**TITLE: OB-17-12 – Status Update for the Kirtland Air Force Base Bulk Fuels Facility Fuel Leak Corrective Action Activities**

# **Review of RCRA Facility Investigation Report for Bulk Fuels Facility Kirtland Air Force Base, New Mexico**

Prepared by INTERA, Incorporated for the  
Albuquerque Bernalillo County Water Utility  
Authority

# LNAPL in Vadose Zone

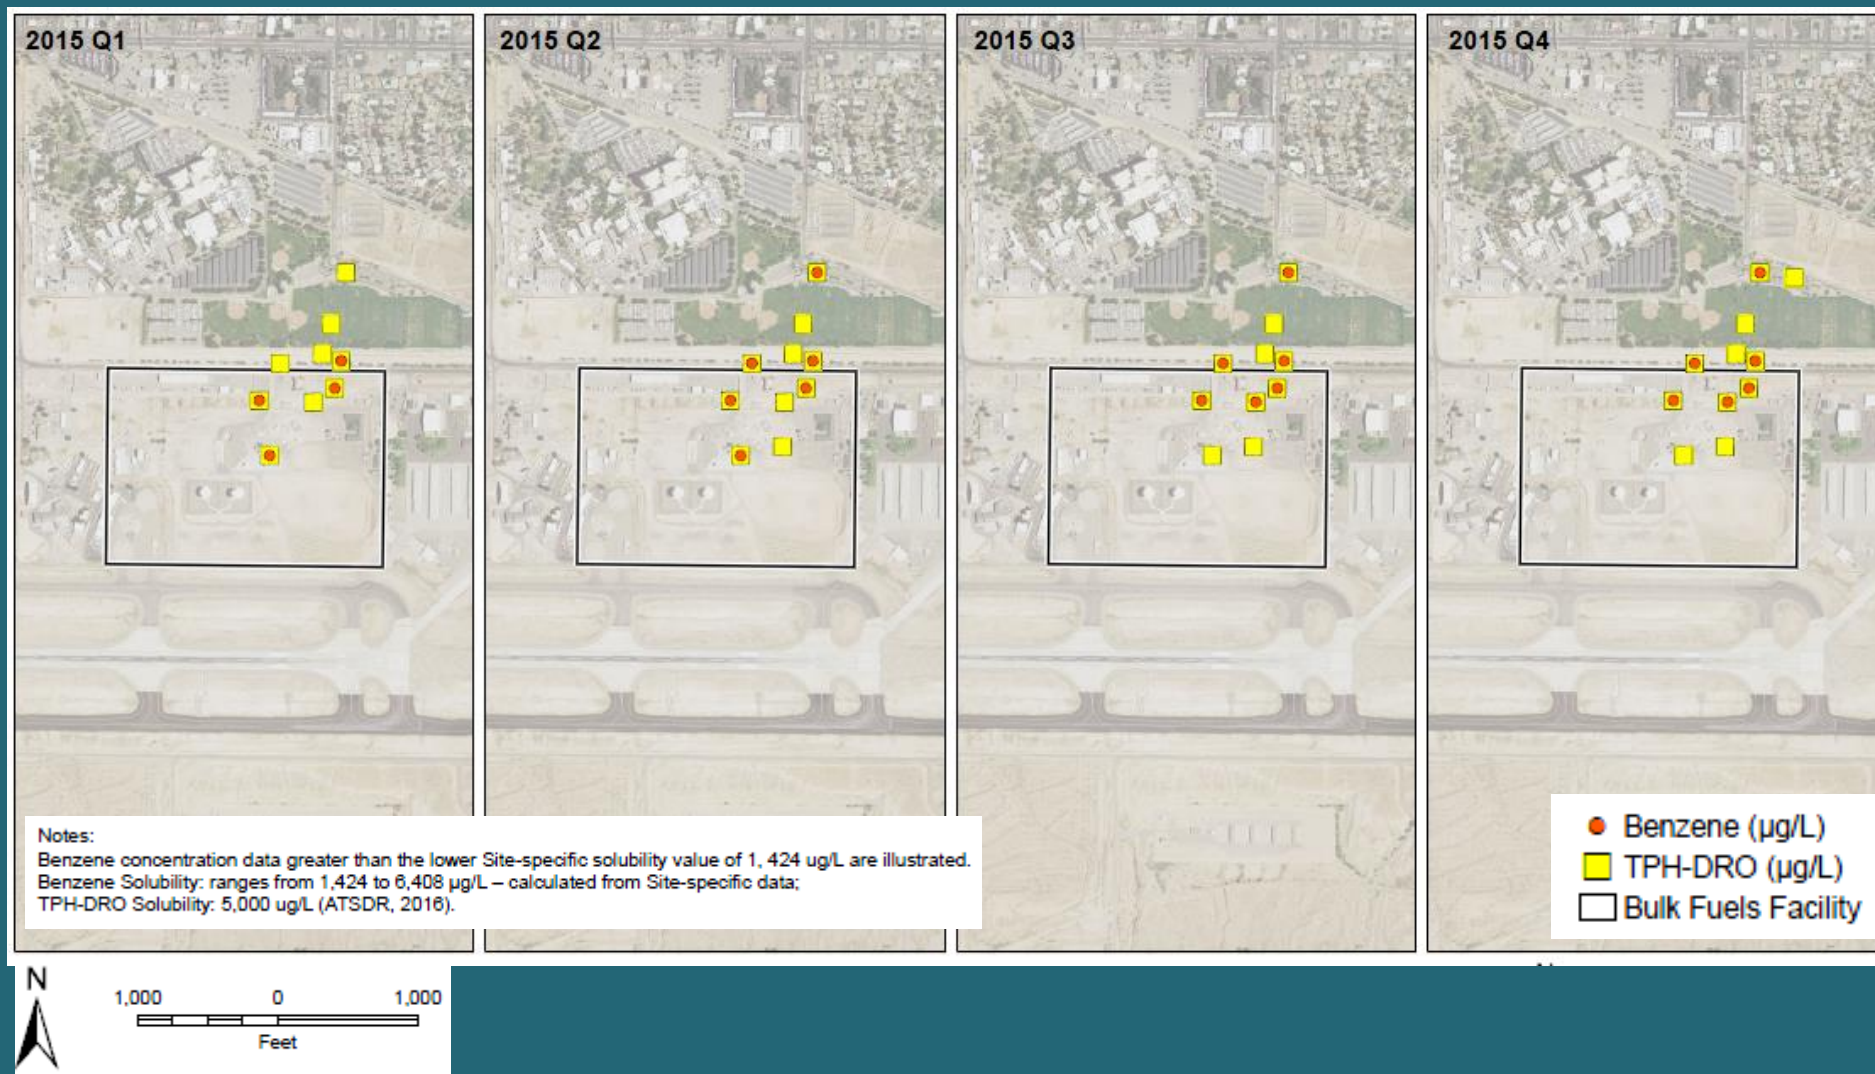
- How much Light NonAqueous Phase Liquid (LNAPL, a.k.a. fuel product) in vadose zone migrates into aquifer now and in future?
- RFI has inadequate data about LNAPL above water table that will act as source
- Data gap may be resolved by proposed coring

# Overestimates Degradation Rates

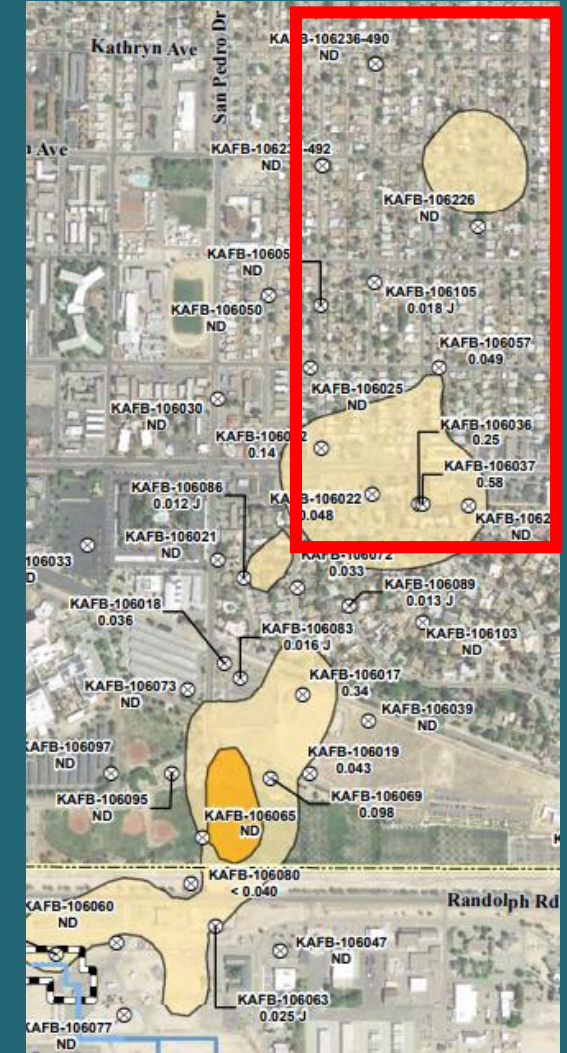
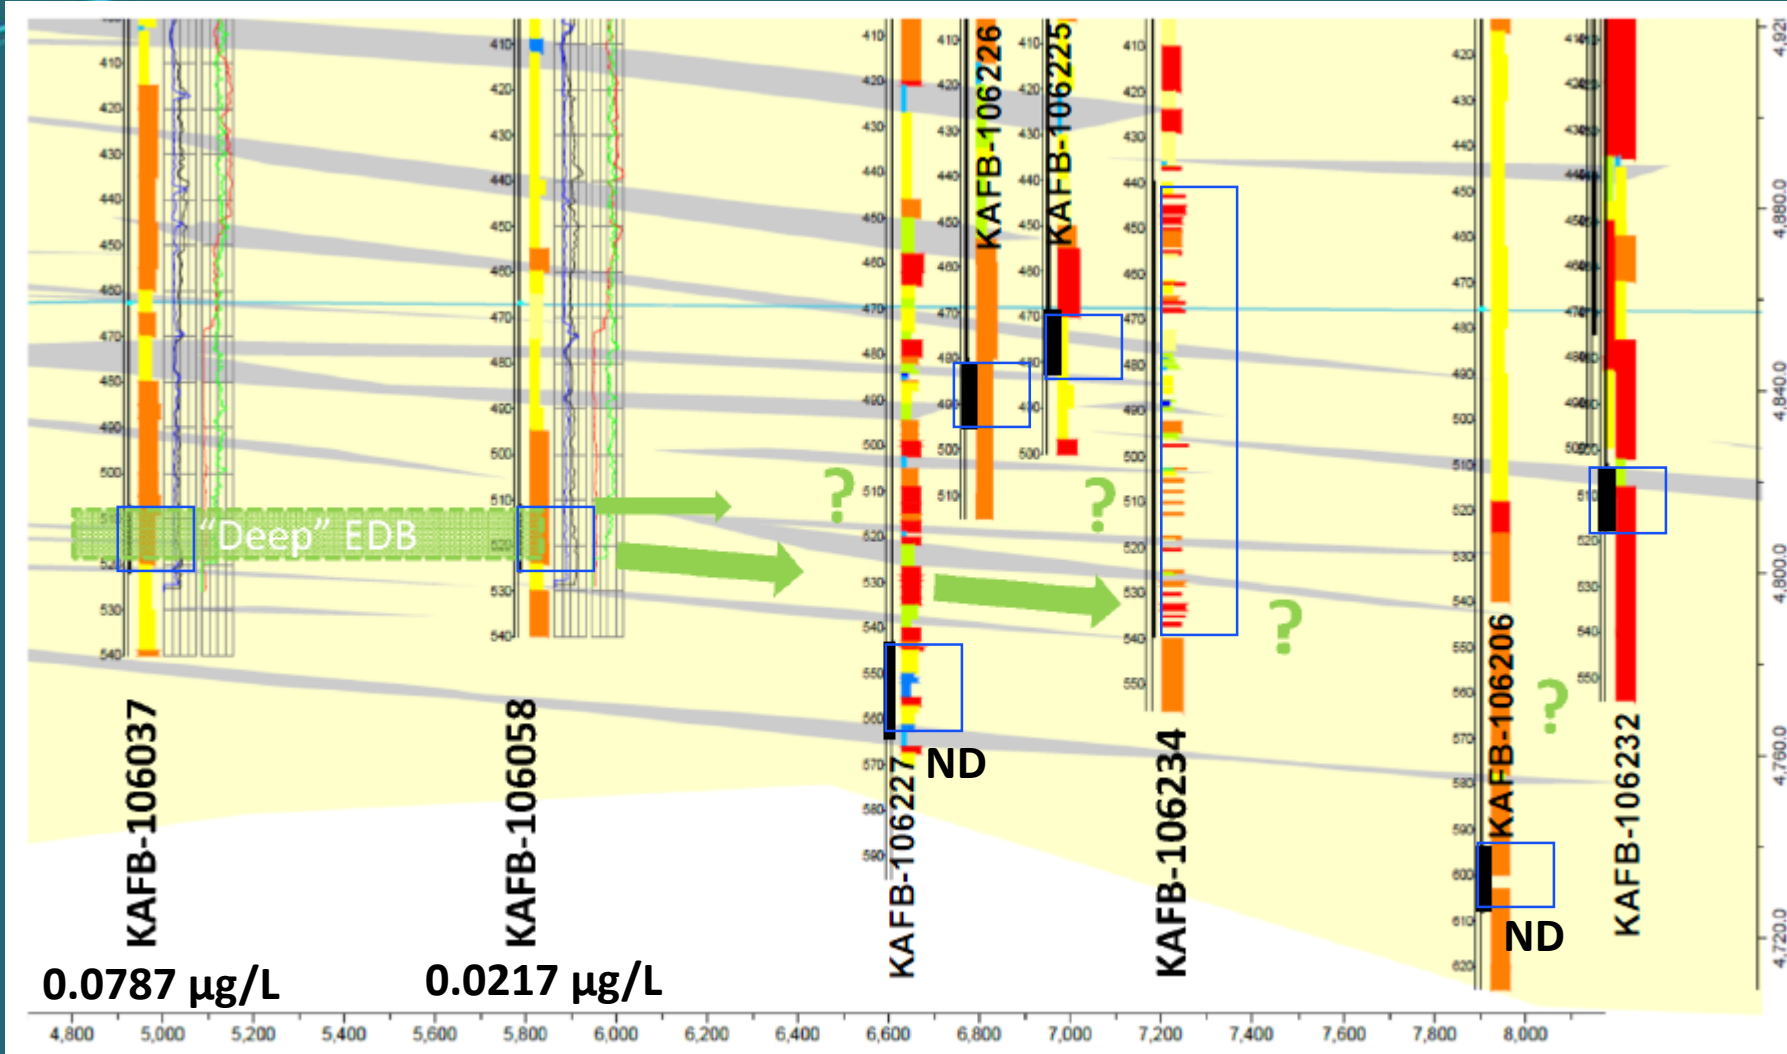
- RFI analysis treats concentration changes as solely caused by degradation – other explanations
- RFI overestimates degradation rates
